Re: 605 Chelsea Street Notice of Intent – Supplemental Information

This Supplemental Information to the Notice of Intent (NOI) for the project at 605 Chelsea Street (the "Project Site") responds to the request for additional information received from the Boston Conservation Commission (the "Commission") during the public hearing held on August 17, 2022.

605 CHELSEA STREET MARINE UPGRADES CARGO VENTURES EAST BOSTON, MA

SEAWALL REPAIR OPTIONS **PLAN SET**

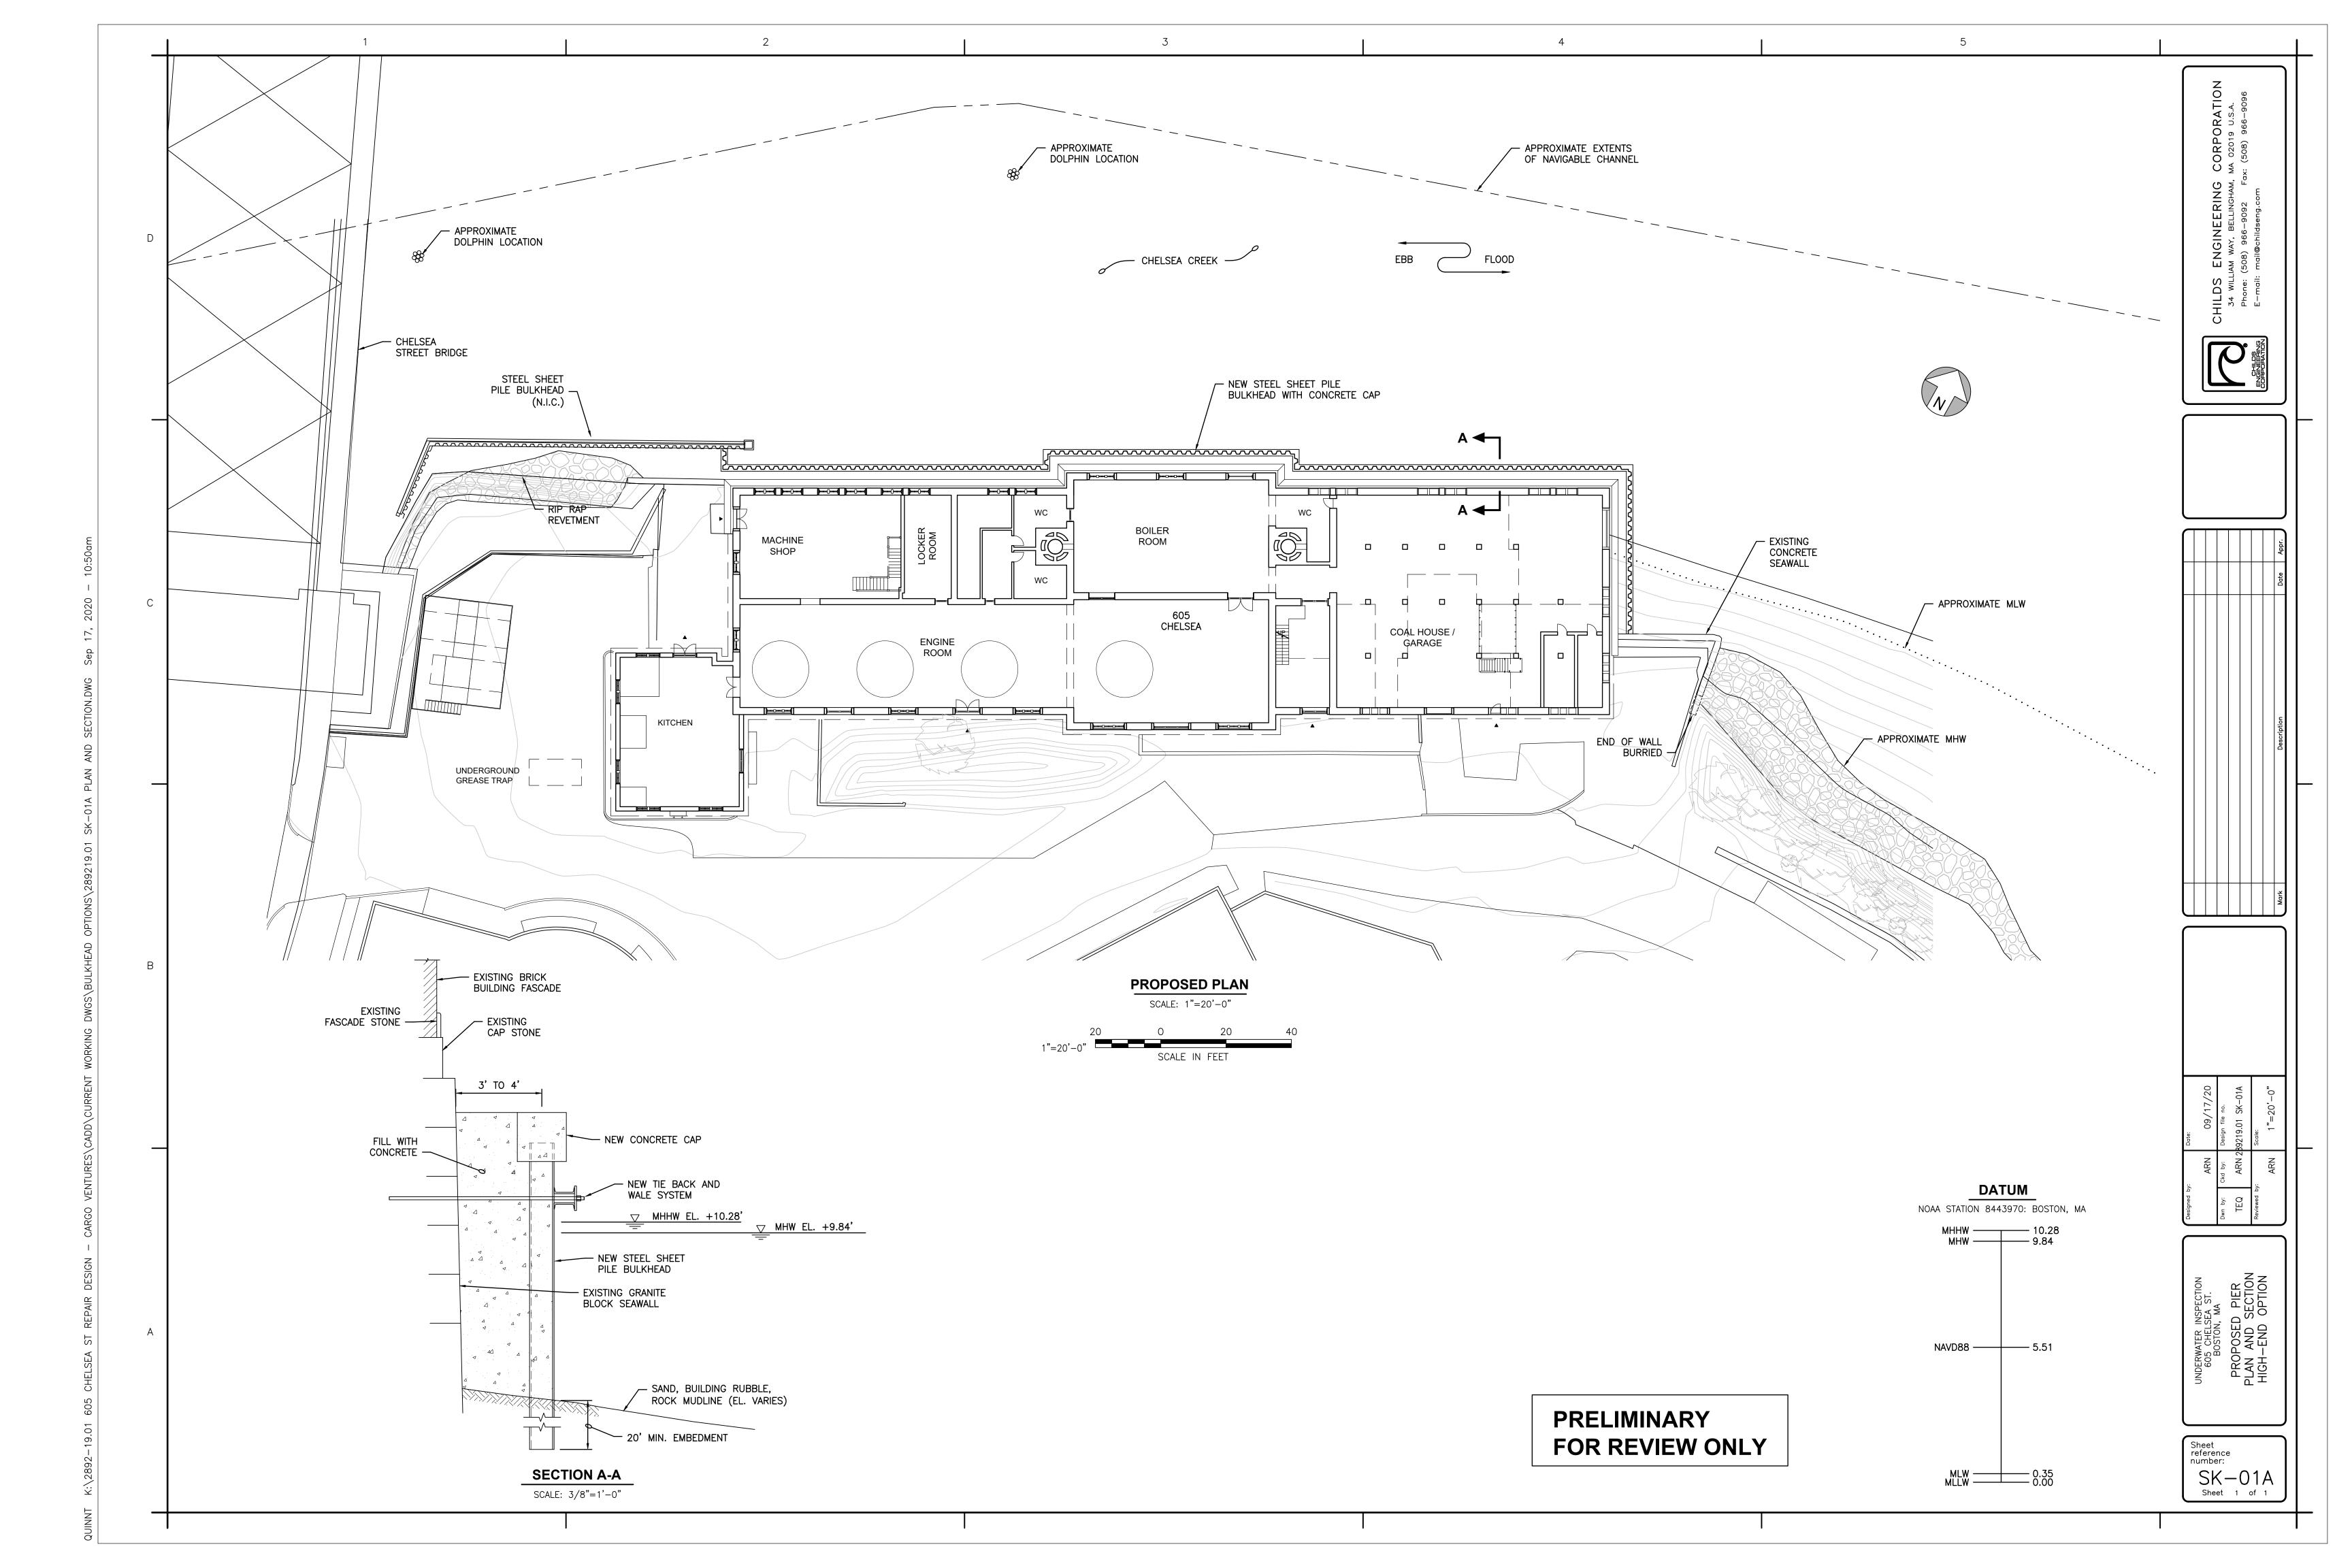
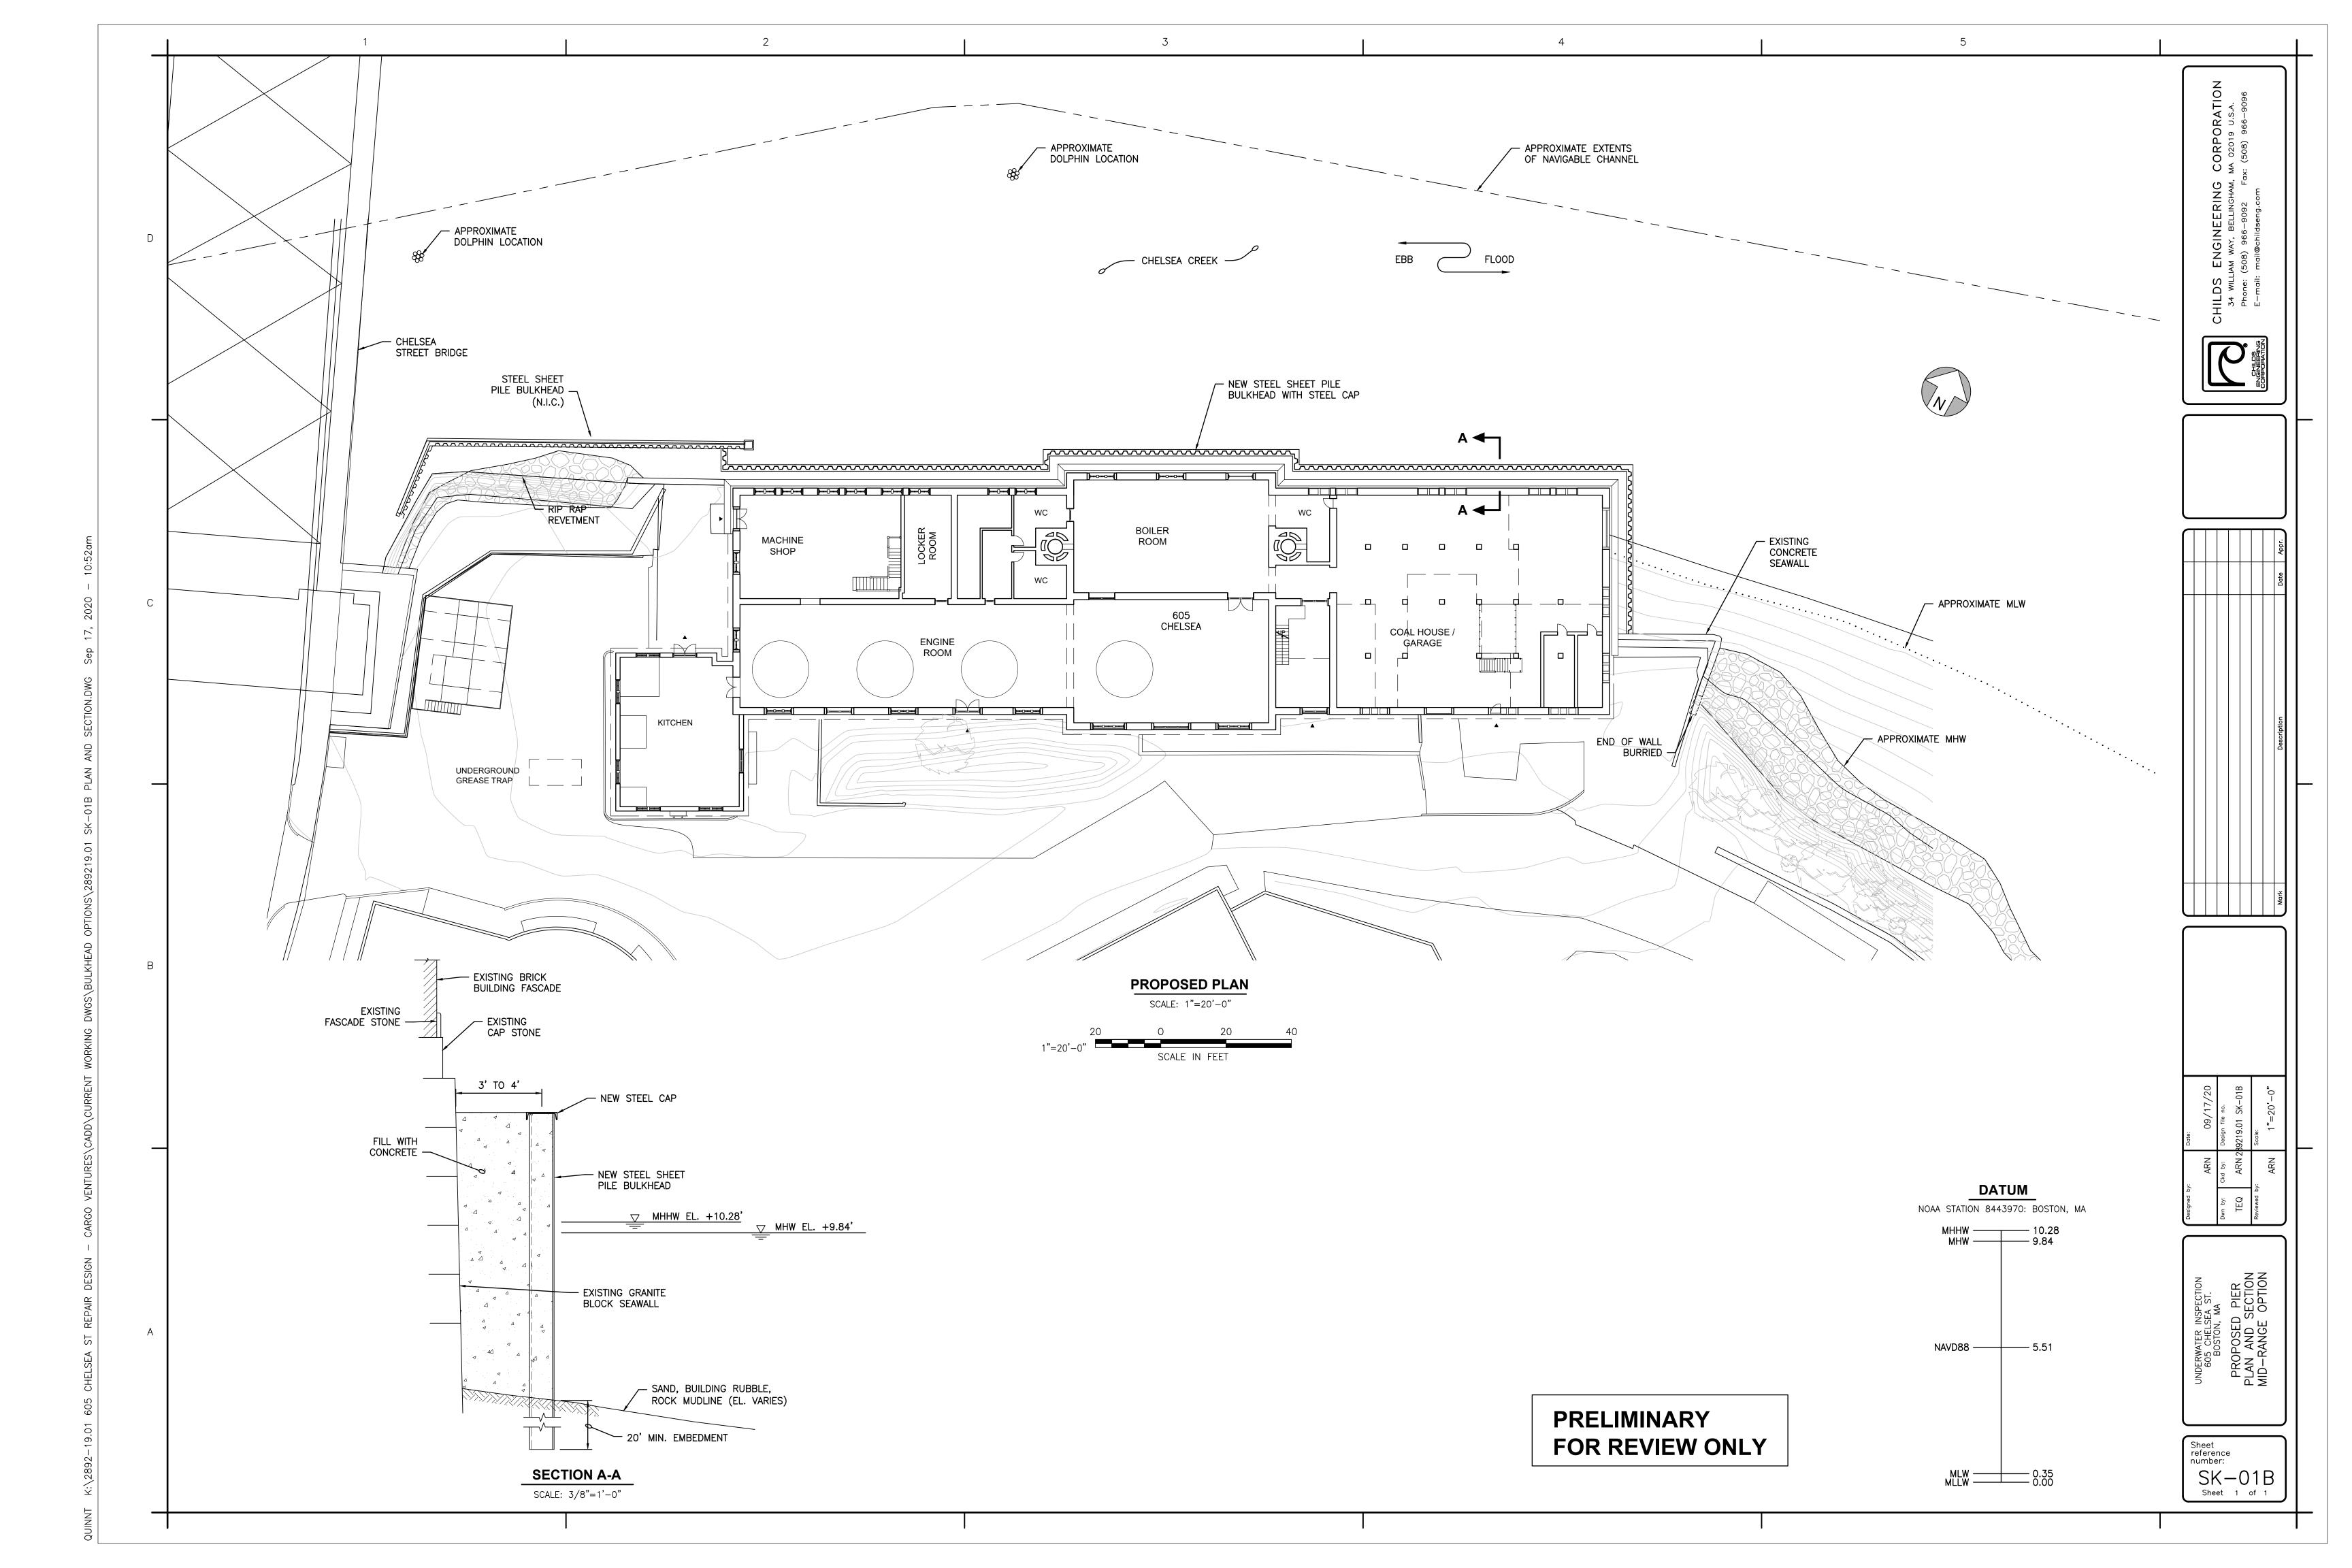
The enclosed Seawall Repair Options Plan Set outlines the three options considered:

Option A: Replace the existing seawall with a new steel sheet pile bulkhead and tieback system. This option assumes that additional load carry capabilities are required due to significant changes in the assumed loads carried by the building. This method requires that a tieback system be installed to provide lateral support of the seawall. The tieback system would require that grouted earth anchors or tierods connecting to an inshore deadman be installed roughly every 6 feet on center along the length of the seawall. The sheet pile would extend to roughly the top of the existing seawall and the annular space between the sheet pile and seawall will be filled with concrete. This method was determined to not be required as there were no significant changes to the loading capabilities of the building from the perspective

- of the seawall. It was also determined that this method would need to overcome significant construction challenges such as the installation of earth anchor or a deadman as well as installing the tierods through the existing stone seawall.

- Option B: This is the option currently outline for the proposed project. This option includes a sheet pile bulkhead installed in front of the existing seawall after all voids are filled with concrete or grout. The annular space between the sheet pile and seawall are to be filled with concrete. This option assumes the existing seawall will maintain original design intents and load carrying capabilities with no significant changes. The sheet pile and concrete will encase the existing seawall and protect from future deterioration and mudline reductions allowing it to continue to function.

- Option C: This option was recommended as the minimum repair effort that should be undertaken to fix the seawall underminings. It requires that a steel sheet pile bulkhead be installed in front of the existing seawall and terminated at MLW. The annular space between the seawall and sheet pile is filled with concrete. The existing seawall from MLW to the top of the wall would remain exposed. The exposed seawall would require additional repairs to the deteriorated section or areas of voids. It was determined that this method is not preferable because the overall repair lifespan would be less than Option B.
